**Committee of Experts on the Transport of Dangerous Goods  
and on the Globally Harmonized System of Classification  
and Labelling of Chemicals**

**Portable tanks**

**Report of the informal working group on fibre reinforced  
plastic (FRP) service equipment for portable tanks**

**Transmitted by the chair of the informal working group on FRP service  
equipment\***

**Figure 42.3.1: Fire resistance test scheme**

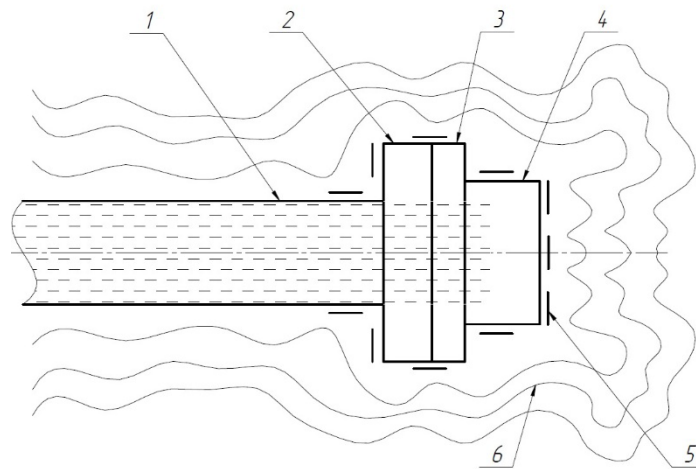
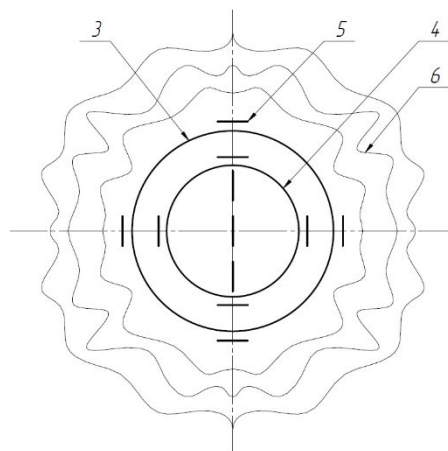
42.3.1 The fire resistance test is carried out for the test specimen installed in a closed position, filled with water with initial temperature of  $20 \pm 5^\circ\text{C}$  under maximum allowable working pressure (MAWP, 6.7.2.1 of the *Model Regulations*) and exposures to flame for at least 30 minutes. [Pressure relief devices are subjected to pressure, which is 10% below nominal pressure set to discharge \(6.7.2.9.2 of the \*Model Regulations\*\)](#). The test specimen shall be completely engulfed in the flame including the gate and seal assemblies. The general test scheme is given in figure 42.3.1. If the test specimen is an part of equipment which is not intended to be the outermost closure in a multi-closure system (such as a valve), then the test specimen may be equipped with a blind flange, at its outermost interface which would otherwise be exposed to flame during the test.

42.3.2 The fire exposure parameters shall comply with paragraph 6.9.2.7.1.5.1 of the *Model Regulations*. The fire shall be equivalent to a theoretical fire with a flame temperature of  $800^\circ\text{C}$ , emissivity of 0.9 and a minimum net heat flux of  $75 \text{ kW/m}^2$  calibrated according to ISO 21843:2018.

42.4.2.2 The general scheme of installation of the test specimen and temperature and heat flow sensors is shown in figure 42.3.1. Measurement errors shall not be more than:
